CONTRACT NO. 1752

REPAIRS TO FLUID BED INCINERATOR NO. 1

ADDENDUM NO. 2

FORCED DRAFT AIR DUCTING
 PLENUM
 ALLEGHENY COUNTY SANITARY AUTHORITY
 PITTSBURGH, PENNSYLVANIA

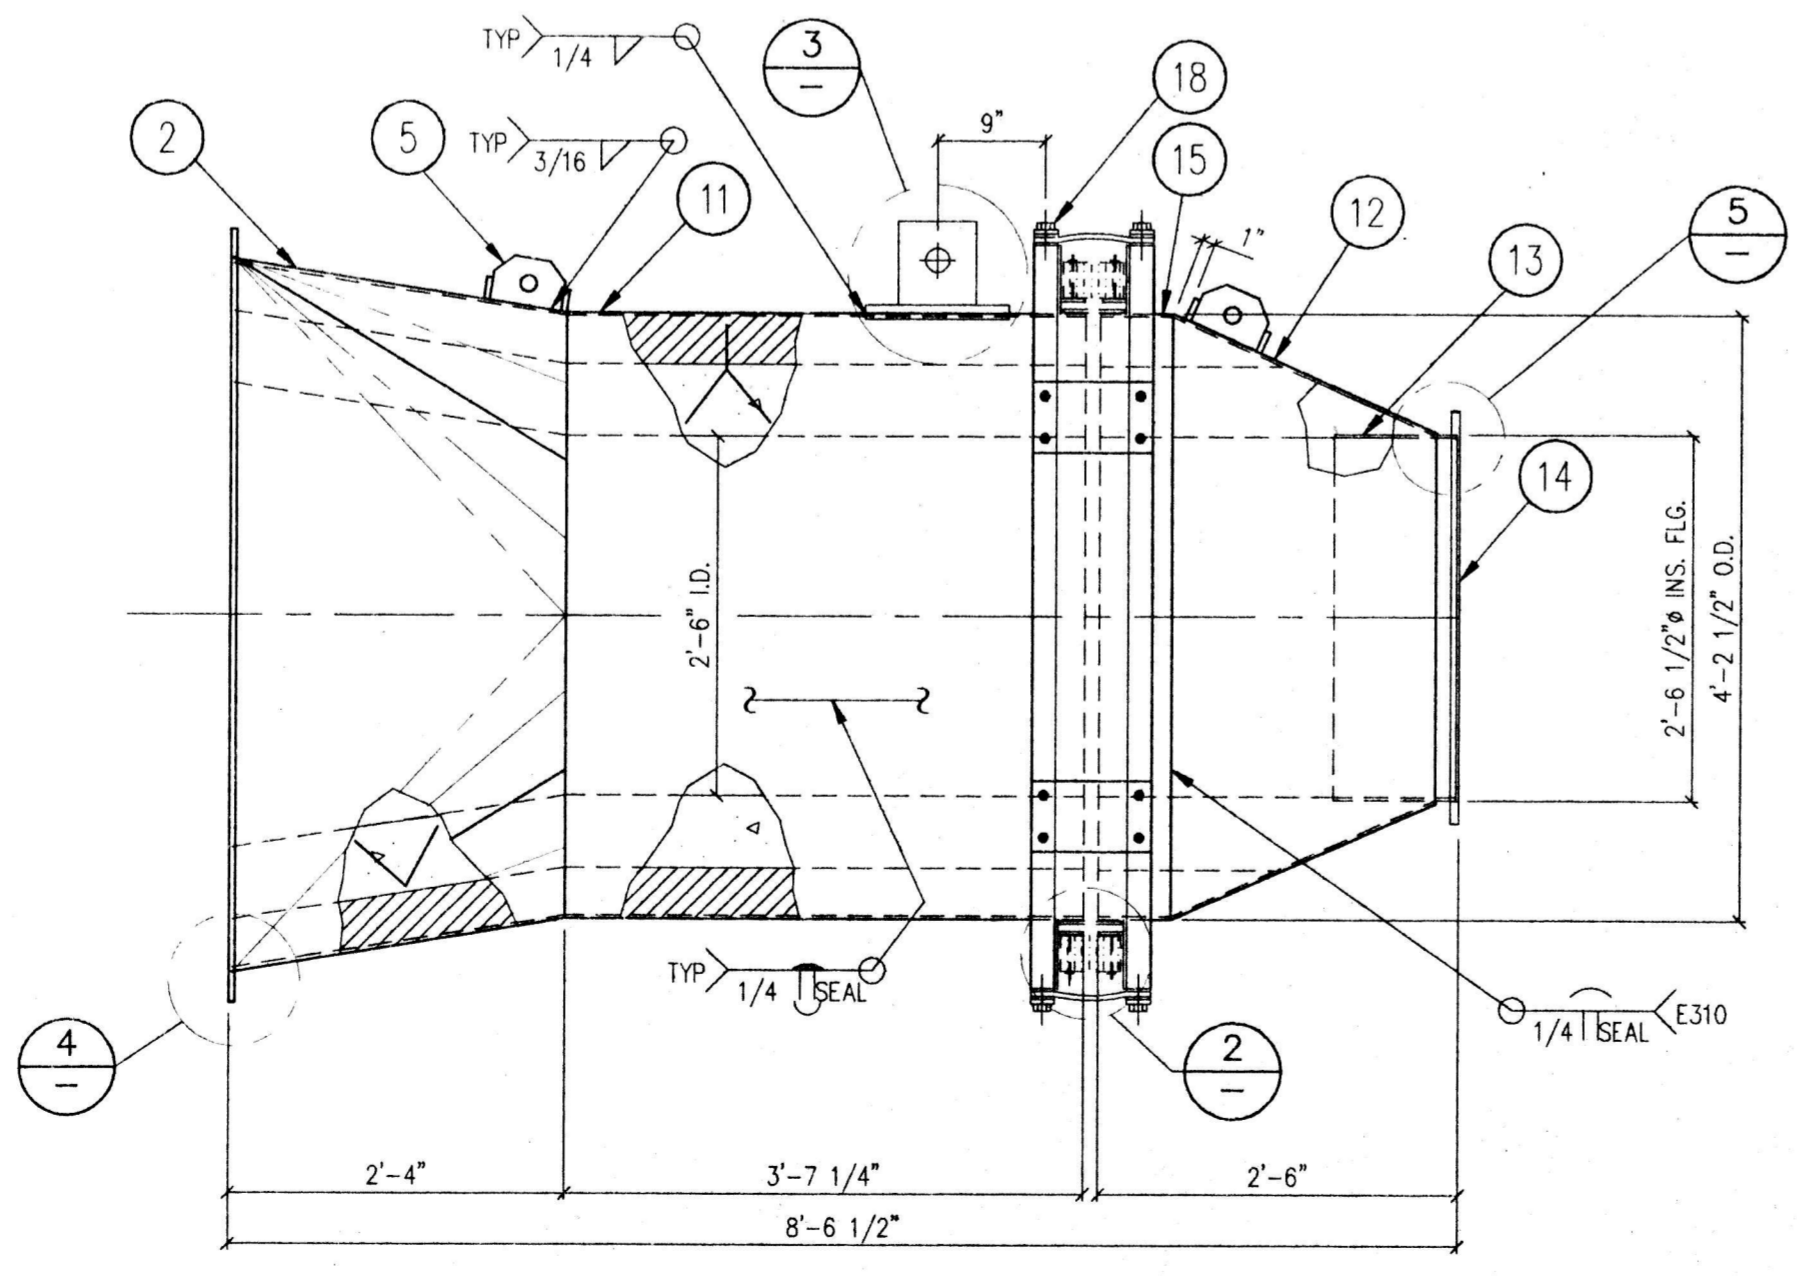
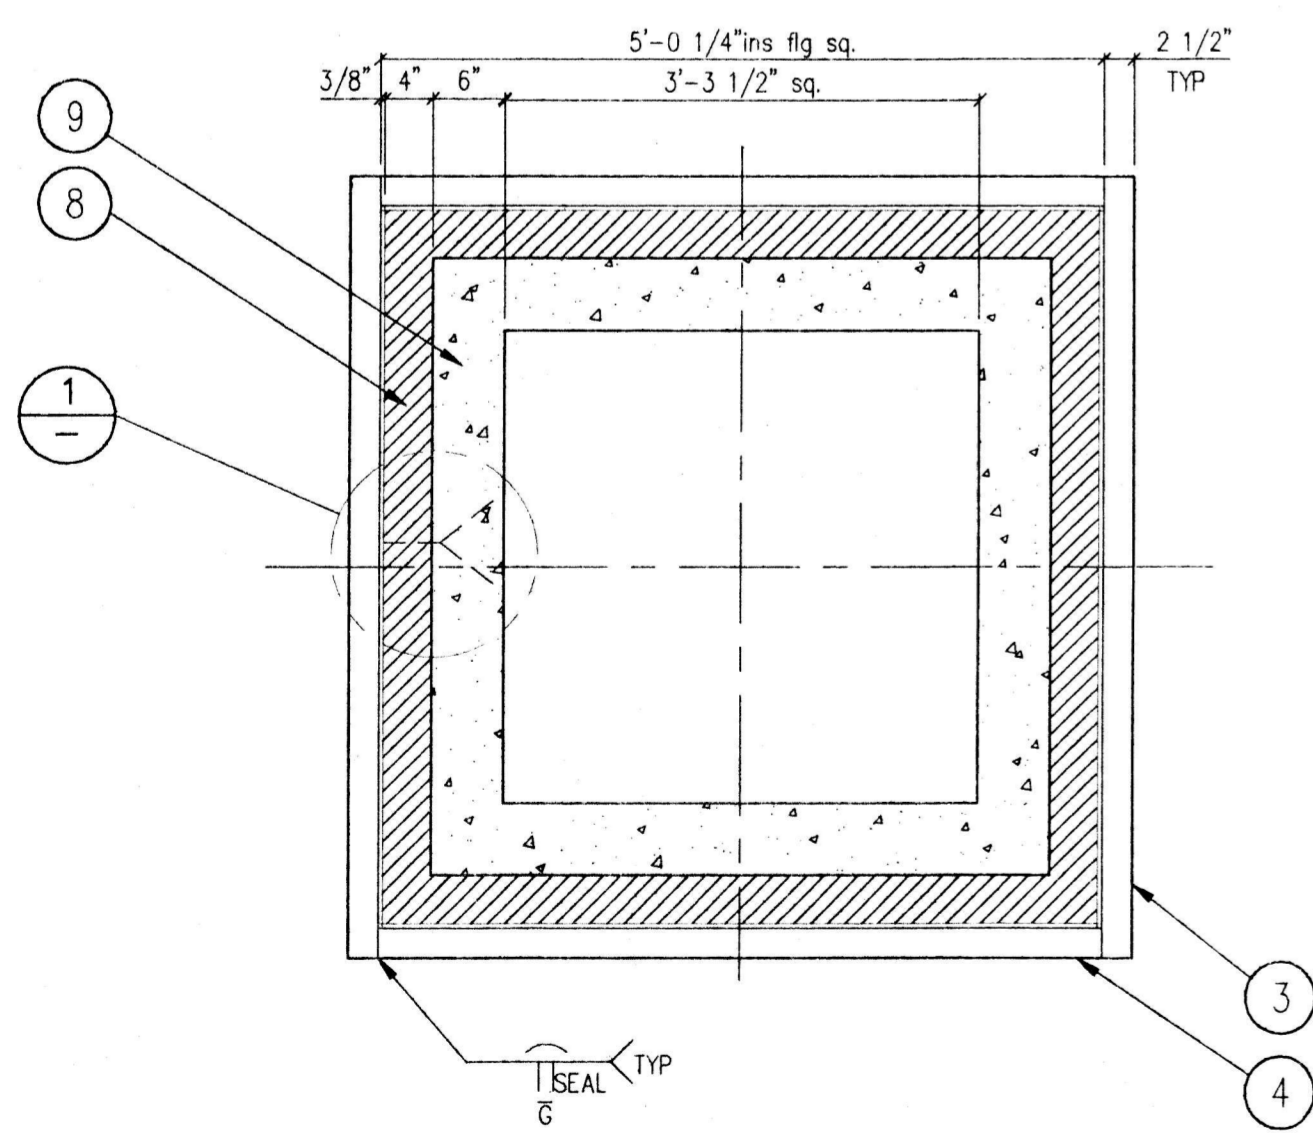
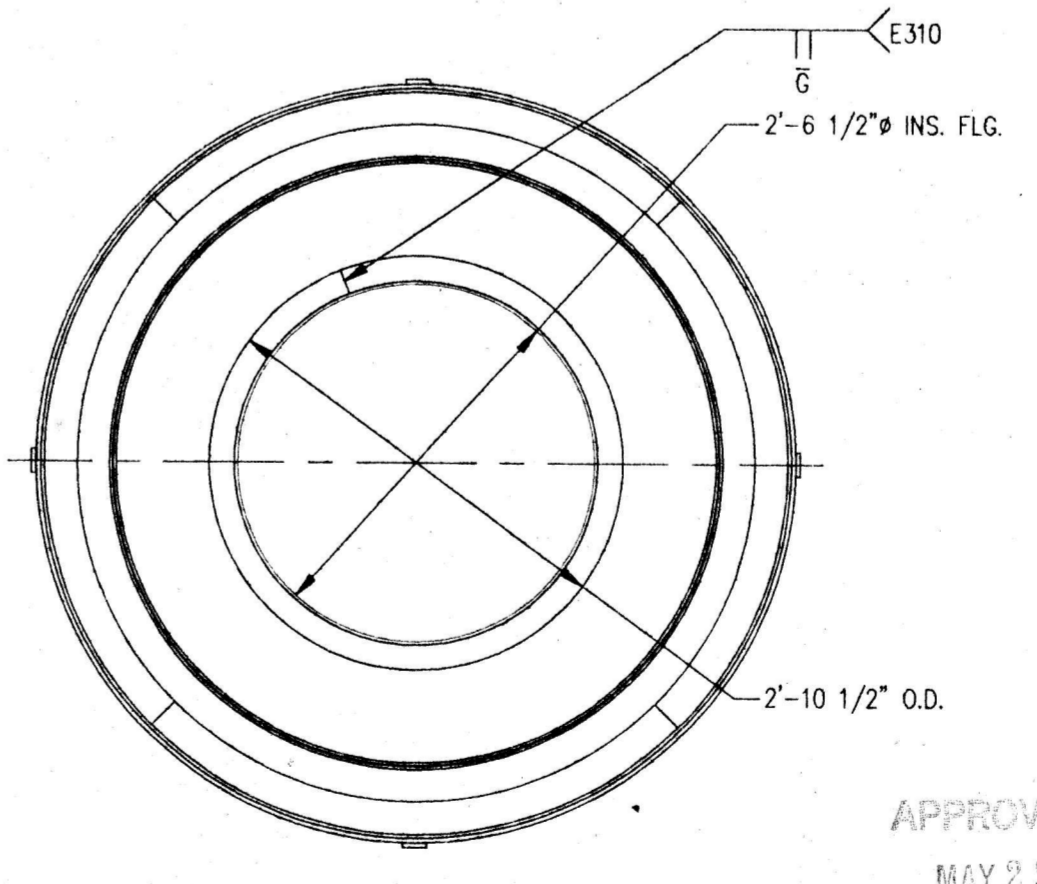
1. Question: Would you happen to have any information on the Expansion Joint and the reducer that is above the Air plenum that is mentioned in the Summary of Work line item #13. They are also on the Print 1001 sheet 3, but there are no dimensions or specs for them.

Response: See the two additional reference drawings, attached to this addendum.
